Gwydir Valley Irrigators Association Inc.

Submission into the review of the Floodplain Management Plan for the Gwydir Valley Floodplain (2016)

Figure 2: Comparison on FMP Management Zones between Namoi and Gwydir

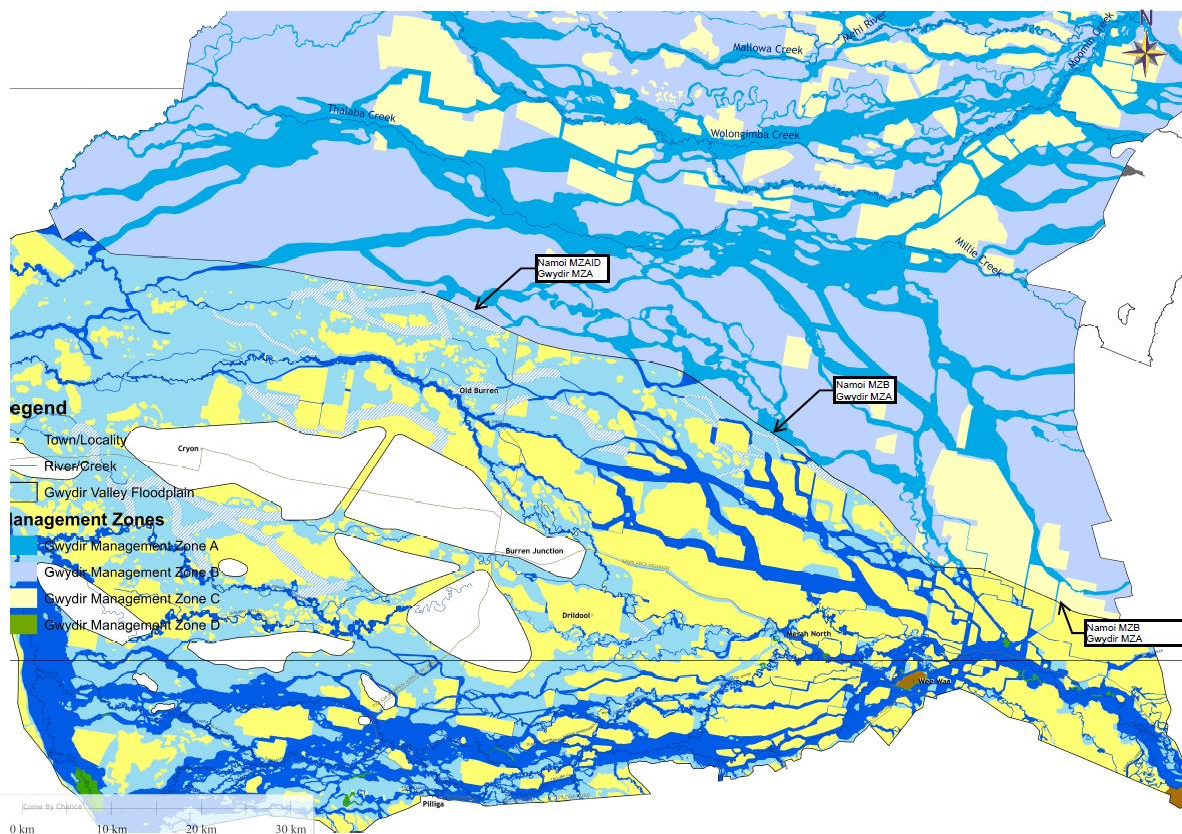
Furthermore, as implementation in neighbouring plan areas have been finalised to the North and South of the Gwydir alignment of all the plans should be assessed. It would be assumed that these boundaries should in practice align and be consistent. As evidenced below in Figure 2 on the southern boundary with the Namoi Valley there is no alignment in some cases particularly around key flow paths in Zone AD or Zone AID. This maybe a result of different criteria being adopted in the different plan areas as raised above with the floodway network analysis.

In addition to our recommendation above to review of the approach to the Gwydir to compare the outcomes of a 0.1m²/sec and 0.2m²/sec on determining floodway networks, we also recommend to enabling additional smoothing of the model to allow for consistency between adjoining plan areas. This would ensure that landholders who may have land on both areas have consistency in zone determination, which is not currently the case.

4. Enabling additional smoothing of the model to allow for consistency between adjoining plan areas. This would ensure that landholders who may have land on both areas have consistency in zone determination, which is not currently the case.
